MANDATORY SERVICE BULLETIN

NO. MSB 40-070/1

Replacement of the passenger door retaining bracket

Retrofit Retaining Bracket

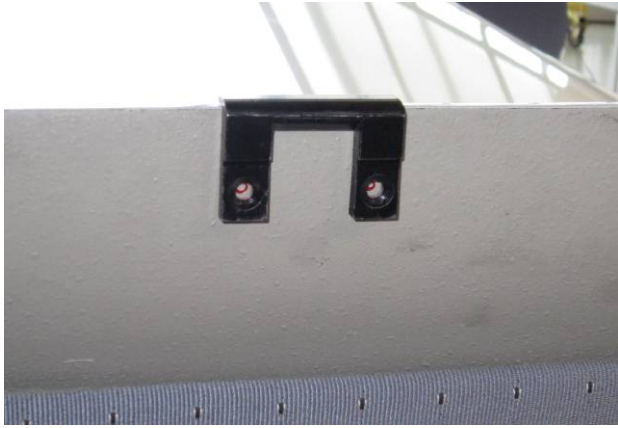
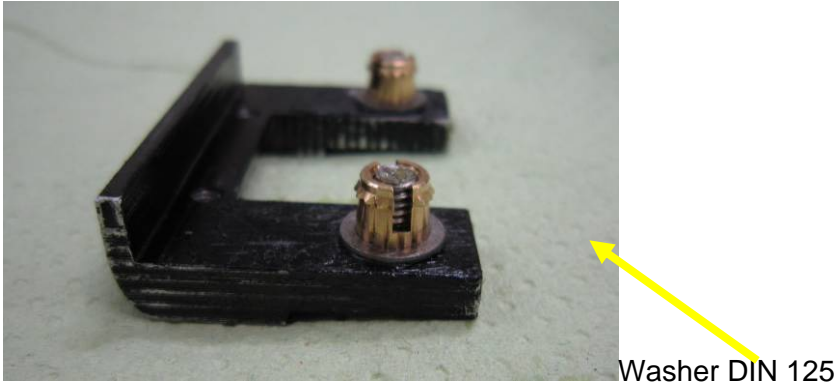
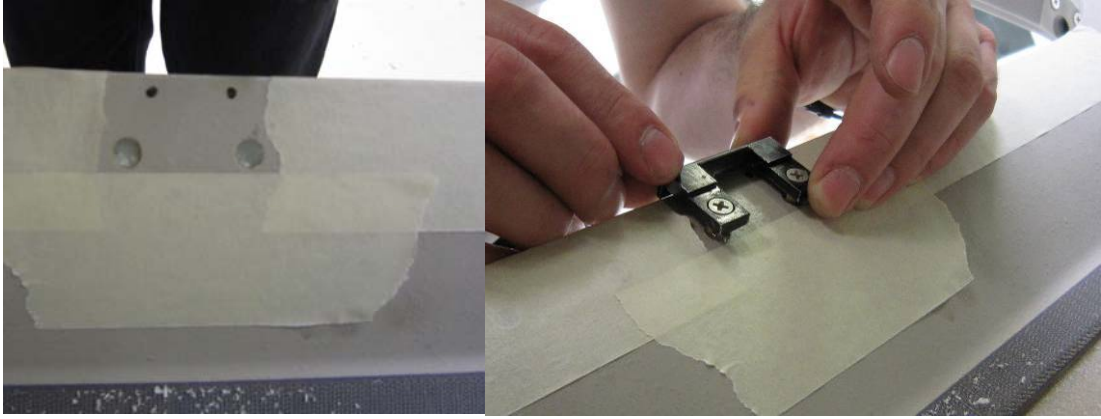
1	Ensure Temporary Revision TR-MÄM 40-428 has been incorporated into the Airplane Flight Manual.
2	Ensure Temporary Revision AMM-TR-MÄM 40-377 has been incorporated into the Airplane Maintenance Manual.
3	<p>If Retaining Bracket DA4-5200-00-69_1 is installed (refer to picture), ensure correct function acc. to AMM Section 52-10.</p> <div style="text-align: center;">  <p>P/N: DA4-5200-00-69_1</p> </div> <p>If Retaining Bracket DA4-5200-00-69_1 is not installed, continue with Action 2</p>
4	Make necessary entries into aircraft logs.

5	Remove the two screws from the fuselage which hold the Retaining Bracket (P/N: DA4-5200-00-69).
6	<p>Install the Retrofit Retaining Bracket (P/N: DA4-5200-00-69-SB) on the old position and mark the position of the two holes from inside the fuselage.</p> <div style="text-align: center;">  </div> <p>Note: Ensure the safety hook fits in the gap between the arms. If not fill the old holes with thickened resin and position the retaining bracket.</p>

7	Remove the Retaining Bracket and drill the two holes with a diameter of 7mm (9/32 inch) and a depth of 7mm (9/32 inch) on the marked positions.
8	<p>Prepare the Retaining Bracket for bonding the thread Insert. Grease the Retaining Bracket, the screws and the washers. Clean the thread insert from grease and dirt.</p>  <p style="text-align: right;">Washer DIN 125</p>
9	WARNING: When handling chemicals always observe Health and Safety Regulations given by the manufacturer of the chemicals.
10	<p>Fill the holes with the two-part adhesive MA300 or thickened resin (L20/H91 thickened with cotton flocks) and install the Retaining Bracket.</p>  <p>Note: L20/H91 mixture: 100 parts resin and 27 parts hardener (by weight). Supplier: Hexion Specialty Chemicals Stuttgart GmbH.</p> <p>Caution: Follow the instructions given in the material data sheet and obey the material safety data sheet.</p>
11	If bonding with Plexus: Cure the installation for one hour. If bonding with resin: Cure 4 hours and post cure 8 hrs 60°C (140°F).

12	Install the Retaining Bracket with screws DIN 963 M3x12-A2-BC and DIN 965-AM4-10-A2.
13	Check function of door locking mechanism i.a.w. AMM Section 52-10.
14	Clean the working area and check for foreign objects.
15	Make necessary entries into aircraft logs.
